APPLICATION NO.	FILING DATE	FIRST NAMED INVENTOR	ATTORNEY DOCKET NO.	CONFIRMATION NO.
10/799,666	03/15/2004	Shih-Siang Jheng	MR1939-98	8574

Office Action Summary

DETAILED ACTION***Claim Rejections - 35 USC § 102***

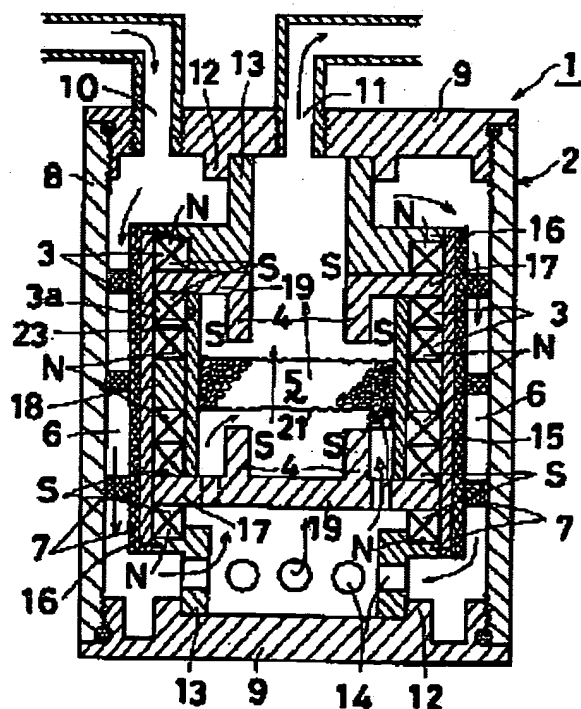
2. Claims 1-3 are rejected under 35 U.S.C. 102(b) as being anticipated by the Japanese

Reference 5-157200, hereinafter '200. '200 teaches a fuel filter including a filtering element,

e.g. each of the annular rings 7 is considered to be a filtering element defining a cylindrical space therein and having an annular "core" sleeve 7 placed there within that is made of a far-infrared ray emitting material [as in claims 1-2]. As for claim 3, gauze nets 21 and side magnets define filter element having a hollow space (filled with 5), wherein the arrangement is surrounding by ray emitter 7. Alternately, for claim 3, even though sleeve 7 (the emitter) is

within the annular rings 7 (the filtering material), the sleeve still anticipates the “mounted around” language of claim 3. The equivalent structure in the specification for the “means for emitting” 112, 6 language of claim 1 is the material 14, 16, 17 or structural equivalents thereof.

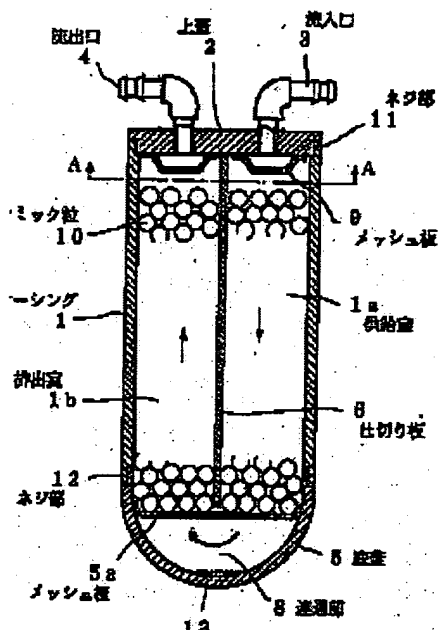
3. Claim 1 is rejected under 35 U.S.C. 102(b) as being anticipated by the Japanese

Reference 6-346806, hereinafter ‘806. ‘806 teaches a fuel filter including a cup-shaped filtering

arrangement 9 and far-infrared ray emitting material 10.
